Comments on Report to Planning and Environmental Protection Committee for 19/00836/OUT - 265 houses at Eyebury Rd. Eye. Peterborough – 25th Jan 2022

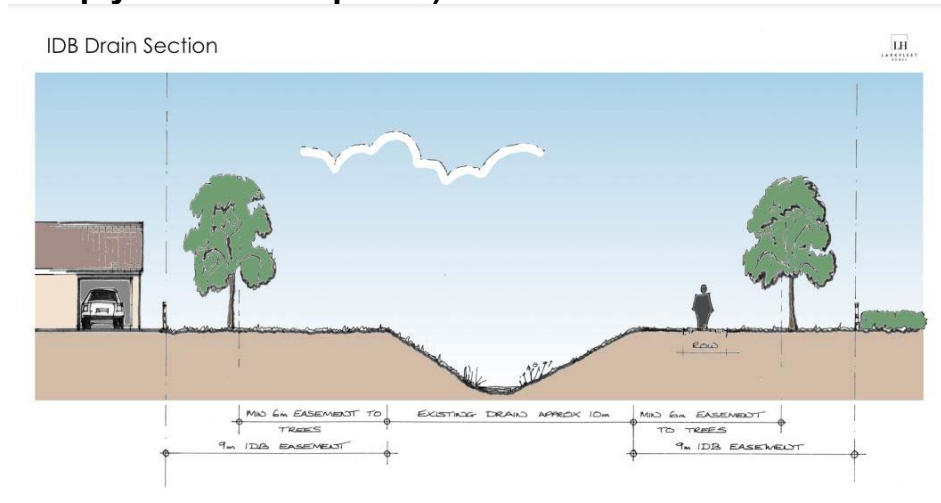
Currently the drain adjacent to the school playing fields does not go into the main drain on the site and as such it floods during the winter and the school playing fields are water logged (see plate 7 above of drain in winter) and photos below taken in Sep 19. There is no detail in the plans on how to drain this water and provide drainage to the new vehicle park and playing fields within the school and for the new houses to be built next to it on the site

If it is to be connected to the nearby SUD with the LEAP in it then this will flood and the children's play area will be unusable

Indicative Master Plan Oct 21 Rev E

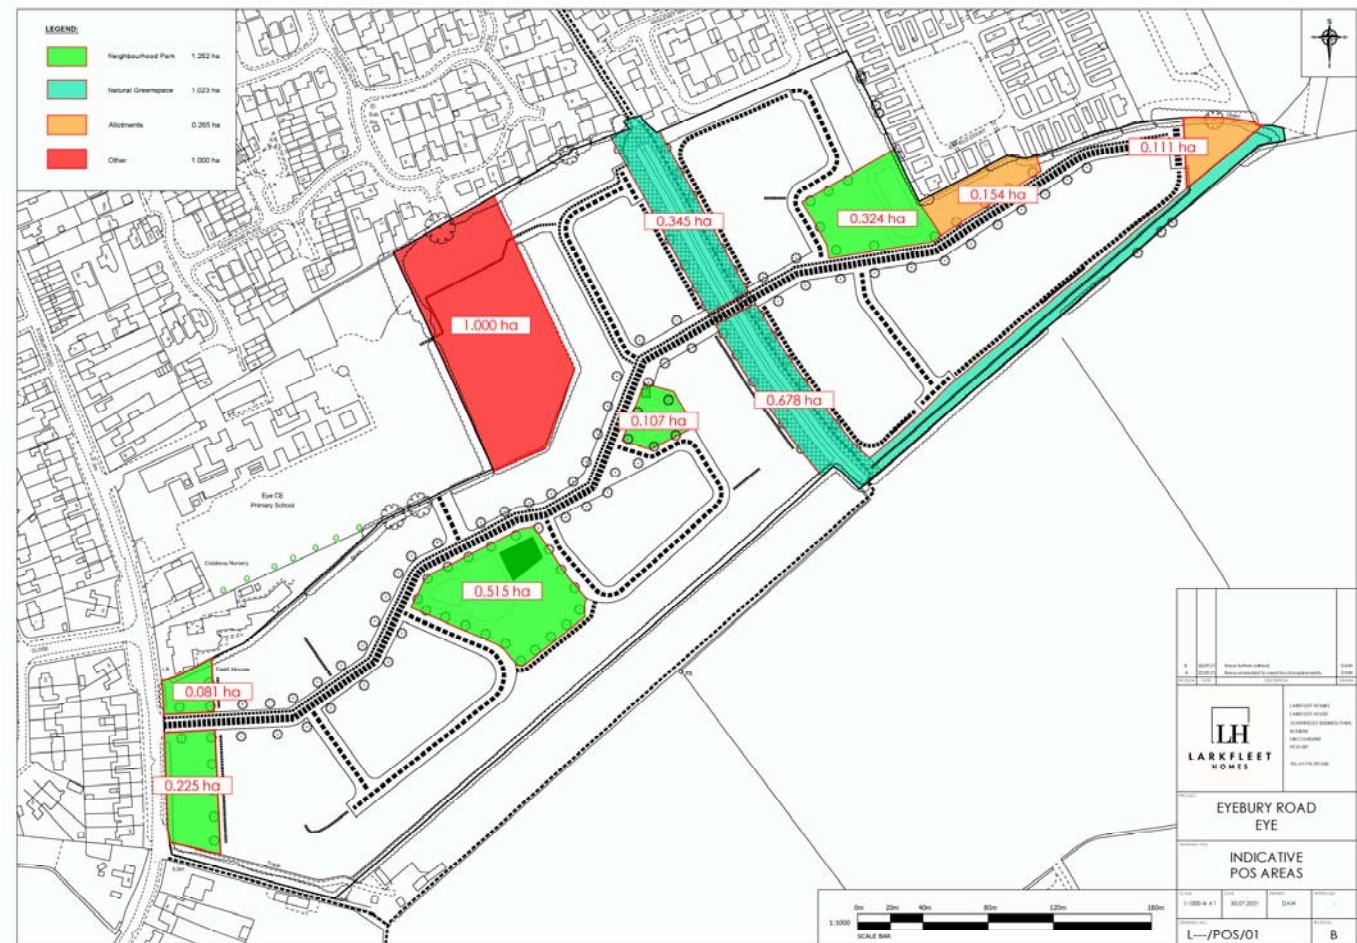
C17-2 That Master Plan Diagram indicates edges of roads are Public Open Space or Natural Green Space, they cannot be used as such for informal recreation

C17-3 There should be no Dry Ponds on the site. NOTE Oct 21 Rev E Indicative Master Plan still shows 3 ponds and 3 SUDs (one being in the LEAP) in the POS allocated, but these are not shown in Oct 21 Rev A Indicative POS Indicative plan ! Additional the Drainage Strategy Documents sent to the IDB indicate 2 of the ponds will be 1.5Mtrs deep, including the one at the SLEAP and the 3rd pond will be 1 Mtr deep. Clearly if there are 3 SUDs and 3 Ponds then more POS needs allocating in the site. Or they should be removed as requested by Landscape Officer if removed how would it affect site drainage and the IDB consultation assessment

Indicative POS Area Map Oct 21 Rev A

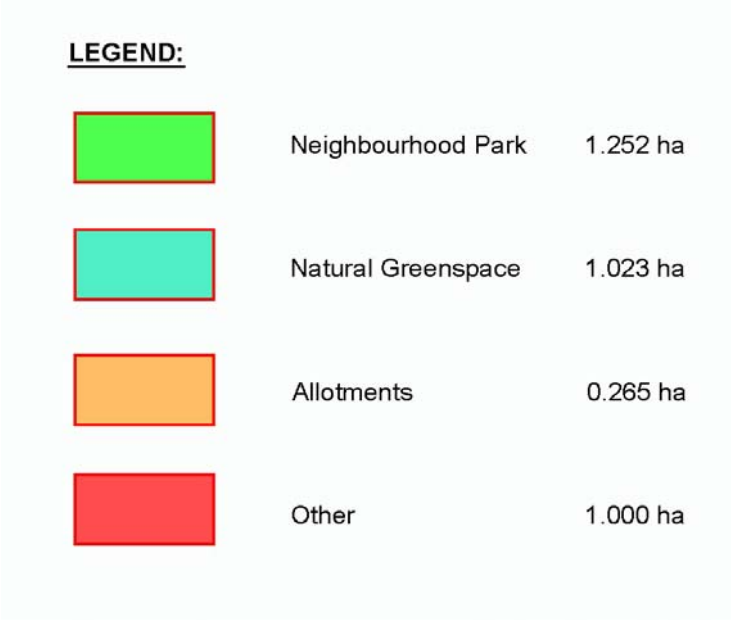
C17-5 The Drainage Border easement area is 9Mtrs either side of the main drain is shown in Indicative POS area map Rev A Dated 211021 as Natural Green Space of a 1.023 Hectare and trees planted on it, clearly this cannot be allocated as such as it will be having IDB Machining using it to maintain the clearance of the main drain as well as depositing silt onto. Therefore another area of the site needs allocating for the 1 hectare of Green Space
